Access Compliance Report

Public Rights-of-Way

(Curb Ramps)

Intersection ID: 16483	Main Street: QUEENS_RD	Cross Street: RADCLIFFE_AV	Location: NE
ADA ID: 9A14B78CD262	Ramp Type: PerpDiag	Initial Pass/Fail: Fail	Overall Compliance: No
Codes/Mitigation Info/Possible Solution		Field Measurements/Component Compliance

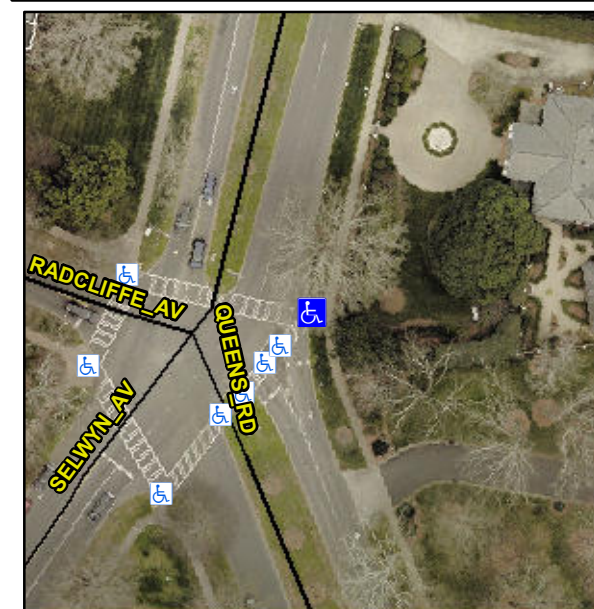
Not Found, R304.2.2, R304.5.3

Compliance	Description	Data	Compliance	Description	Data
N/A	Ramp Length (in)	103.5	No	Ramp Slope (%)	11.3
Yes	Ramp Width (in)	49.0	No	Ramp XSlope (%)	2.1
N/A	Flare Type LT	N/A	N/A	Flare Type RT	N/A
N/A	Flare Slope LT (%)	N/A	N/A	Flare Slope RT (%)	N/A
N/A	Flare Traversable LT?	N/A	N/A	Flare Traversable RT?	N/A
N/A	Landing Length (in)	N/A	N/A	DWS Provided?	N/A
N/A	Landing Width (in)	N/A	N/A	DWS Contrast?	N/A
N/A	Landing Slope (%)	N/A	N/A	DWS Length (in)	N/A
N/A	Landing X Slope (%)	N/A	N/A	DWS Full Width?	N/A
N/A	Landing Curb? (Y/N)	N/A	N/A	DWS Offset (in)	N/A
N/A	Shared Landing?	N/A			
N/A	Gutter Ponding?	N/A	N/A	Gutter Slope (%)	N/A
N/A	Gutter Lip Ht (in)	N/A	N/A	Gutter X Slope (%)	N/A
N/A	Painted X Walk1?	Yes	N/A	Painted X Walk2?	Yes
	X Walk 1 Direction	To NW		X Walk 2 Direction	To SW
N/A	X Walk 1 Width (in)	109.0	N/A	X Walk 2 Width (in)	72.0
	X Walk 1 Slope (%)	6.3		X Walk 2 Slope (%)	3.4
	X Walk 1 X Slope (%)	1.2		X Walk 2 X Slope (%)	4.5

Remove & Replace Curb Ramp With Two New Directional Ramps or Equivalent.
